MOTOR COACH  
INDUSTRIES

**RE: DURA AUTOMOTIVE SYSTEMS, INC. WINDOW DE-BONDING RECALL**  
**NHTSA #: 07E042000**

# Service Bulletin No. 290

<b>MODEL</b> D4005 / D4505 Series Coaches	<b>TYPE</b> Field Change Program	<b>SECTION/GROUP</b> 3-Body	<b>DATE</b> June 10, 2008
<b>SUBJECT</b> DURA AUTOMOTIVE SYSTEMS WINDOW DE-BONDING			
<b>CONDITIONS</b>

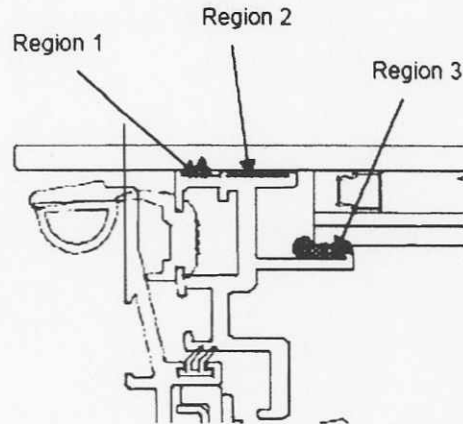
Prior to 7/19/06 Region 1 was to be primed with a different primer than Regions 2 and 3. The analysis of windows exhibiting de-bonding, manufactured between 7/1/2005 and 10/31/2005

indicate either missing or incorrect placement of primer in Regions 1 & 2. All windows (including service replacement) are identified via applied sticker with the window manufacturing date.

Post 7/19/06, Region 1, 2 & 3 all use the same primer and this uniformity remedies any process inconsistencies. All windows (including service replacement) are identified via applied sticker with the window manufacturing date.
